Docket Item # 7 & 8 BAR CASE # 2014-0030 & 31

BAR Meeting March 5, 2014

ISSUE: Permit to Demolish/Capsulate and Addition/Alterations

LOCATION: 700 South Lee Street

Rear / Side Elevation

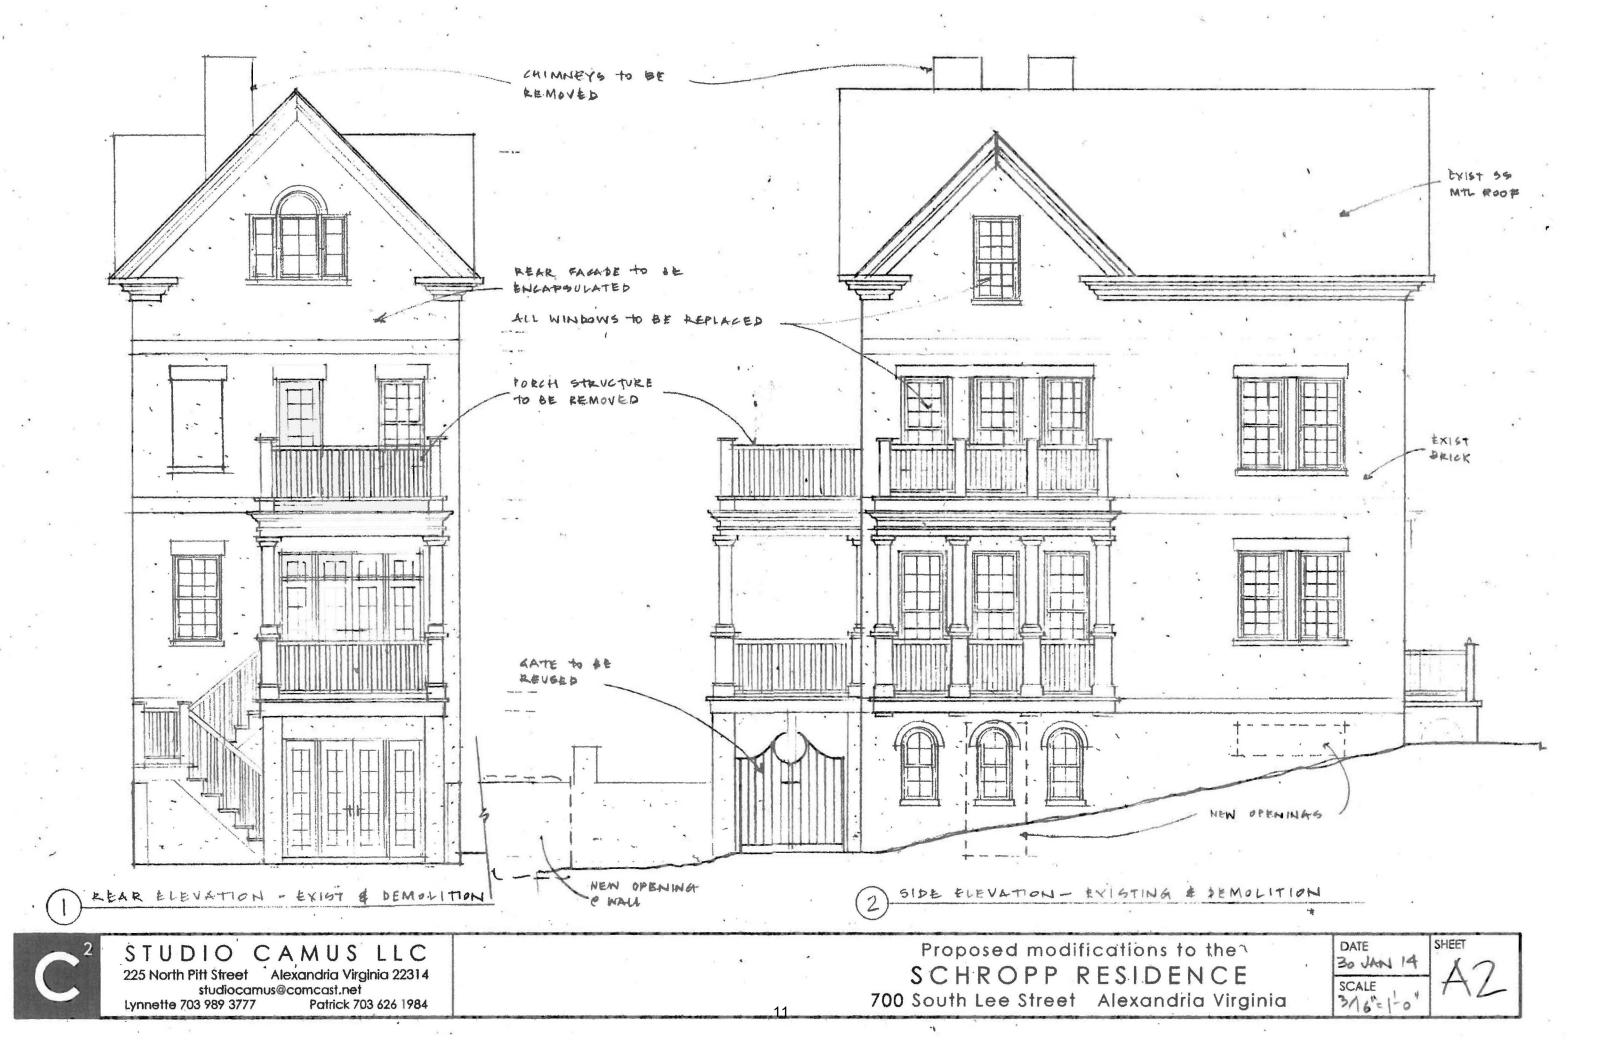
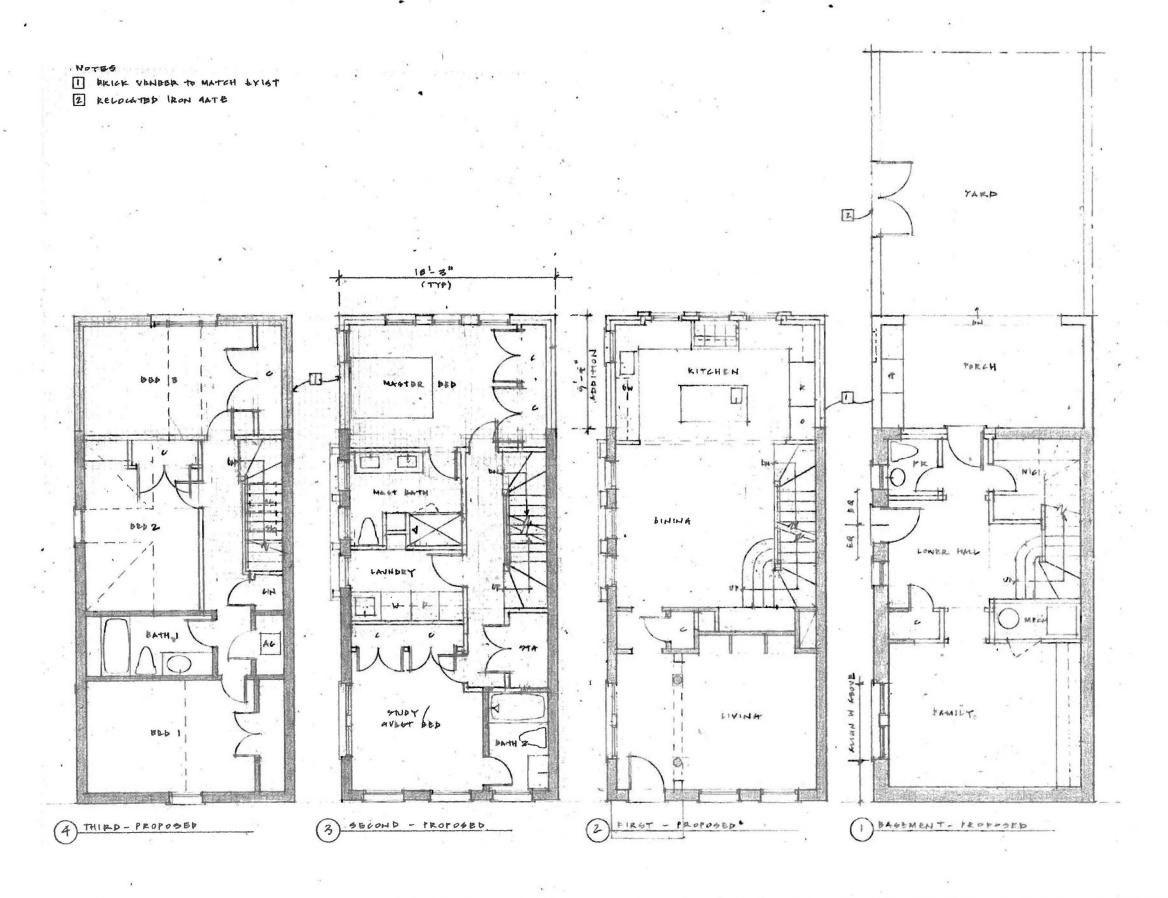
The *Design Guidelines* encourage "designs that are respectful of the existing structure and which seek to be background statements or which echo the design elements of the existing structure." In the opinion of Staff, the design of the addition is compatible and will likely appear as if it is part of the original construction. While the Guidelines generally discourage additions that mimic the architecture of the main building, Staff supports the replicative style of the proposed addition on this modern house and believes that it is visually more balanced than the existing elevation on Franklin Street.

The addition, which projects no farther into the yard than the existing porch but with a greater mass, is consistent with mass and setback of the two the adjacent townhouses on South Lee Street.
